Prepared for: Hearing Commissioners – Te Tai o Poutini Plan
Prepared by: Paul Wilson, Expert Witness, Lighting, Xyst
Date: 07 May 2024
Subject: **Lighting**

Purpose of Report

1. The purpose of this report is to respond to the “Assessment of Lighting Effects on Threatened and Endangered West Coast Species”, dated April 2024 and prepared by Wildlands and whether further changes are needed to the LIGHT chapter under the Proposed Te Tai o Poutini Plan to manage the effects of lighting on threatened and endangered species.

Figure 2 Effect of unshielded lights on vertical illuminance

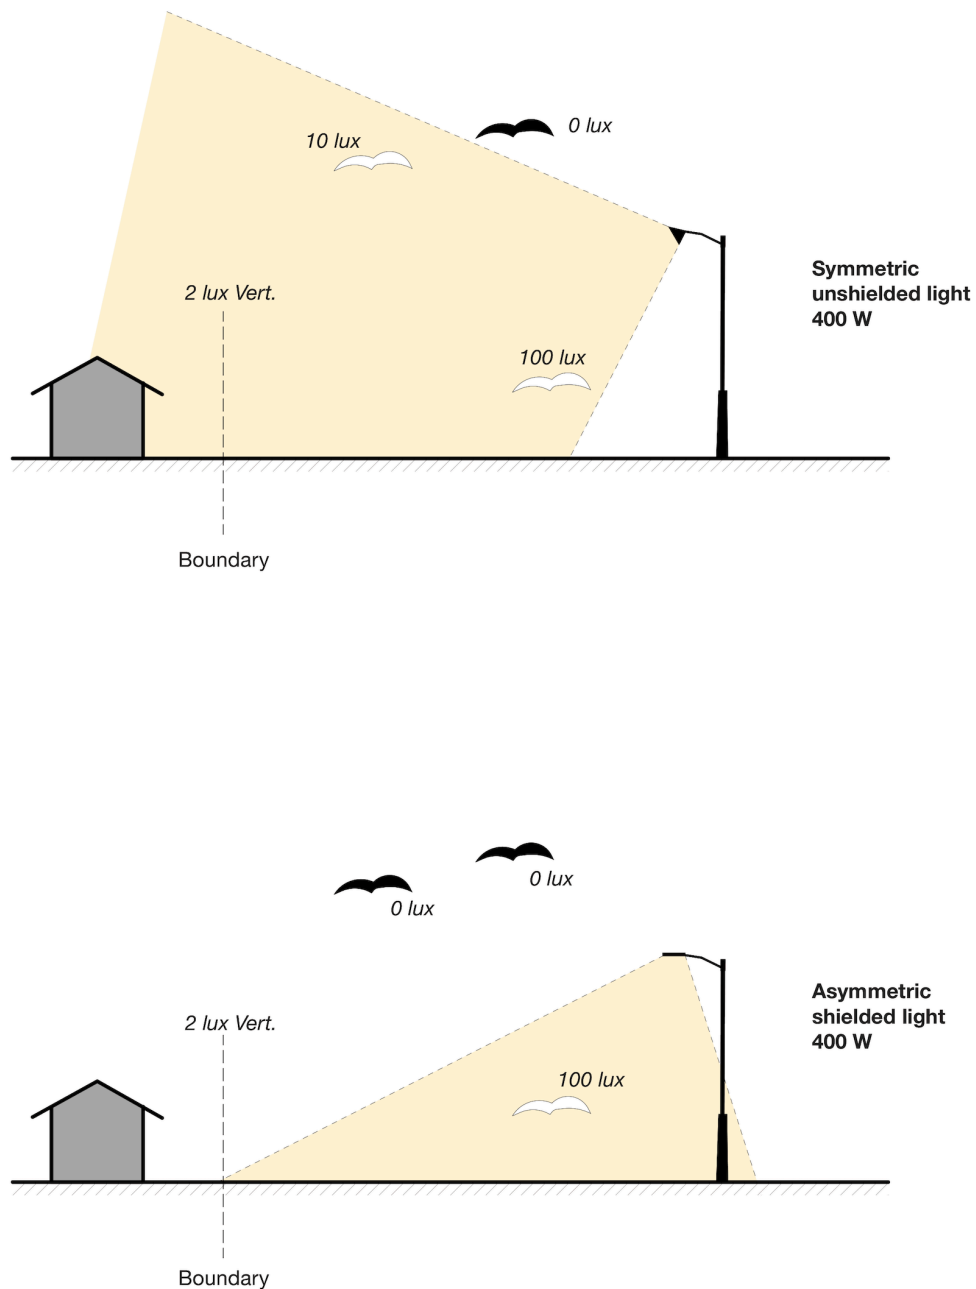
4. I agree with Wildlands recommendation that all lights should be shielded to prevent any vertical light however I do not agree that maximum lux level which is measured as received at a neighbouring boundary needs to be reduced.
5. A lower lux level will not necessarily prevent high levels of vertical illumination *within* the site.
6. If the prescribed lux level at the property boundary was reduced to 5 lux as suggested there could still be significant vertical illumination if upward light spill is not controlled. Figure 2 illustrates this.

7. I suggest that rather than focusing on the lux level at the receiving property boundary it would be more effective to control upward light as suggested by Wildlands.
8. ASNZS 4284 has introduced limits on the upward light ratio which are between 0.00 for light sensitive areas and 0.03 for areas of high district brightness. District Plans are beginning to adopt controls on upward light spill in line with ASNZS 4284 and greater
